Fwd: TDOT - Bridge Fed.ID. # 05S24980003 (Wildwood Rd. over Branch) in Blount County Requires Weight Limit Posting.

BRIDGE INSPECTION REPORT (CULVERTS)

INSPECTION TEAM'S SUMMARY

Subject: New Weight Limit Posting Requirement
Bridge Federal ID No. 05S24980003
Bridge Location No. 5 - 01246 - 4.57
Wildwood Rd. over Branch
Blount County

Tennessee Standard Weight Posting Signs Local Bridges

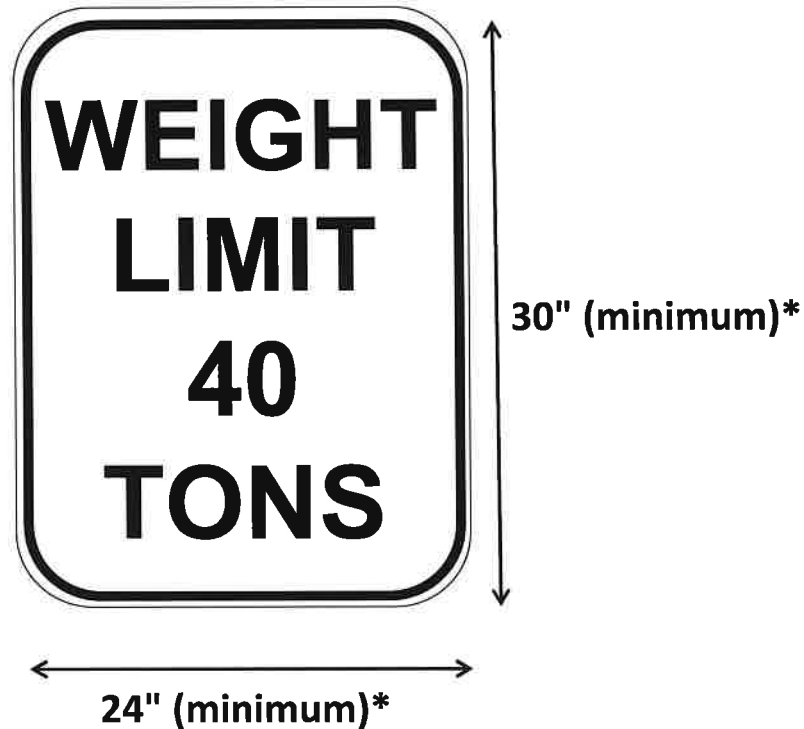
We have completed the most recent evaluation of the subject bridge and have determined that the bridge is now required to be posted for a gross weight limit of 40 tons for all vehicles.

Posting signs shall meet the minimum requirements of the MUTCD (Manual of Uniform Traffic Control Devices). See the attached "Tennessee Standard Weight Posting Signs" for additional details.

- o The TDOT Structures Division will determine the appropriate vehicle load limit in tons.
- o All signs must meet the requirements of the Manual on Uniform Traffic Control Devices (MUTCD).

- o The clear height of the sign shall be 5'-0" in rural areas and 7'-0" in urban areas.
- o Signs should be fabricated using flat sheet aluminum blanks 0.100" thick using reflective sheeting of Encapsulated Lens or Micro-prismatic Lens material meeting or exceeding the minimum requirements for Type B or better as specified by AASHTO M 268.

- o All signs shall be installed and maintained to be legible, upright, and clearly visible.
- o Per MUTCD 2B.59, weight posting signs shall be located in advance of the bridge. The speed limit, road conditions and traffic should be considered when determining the appropriate location.
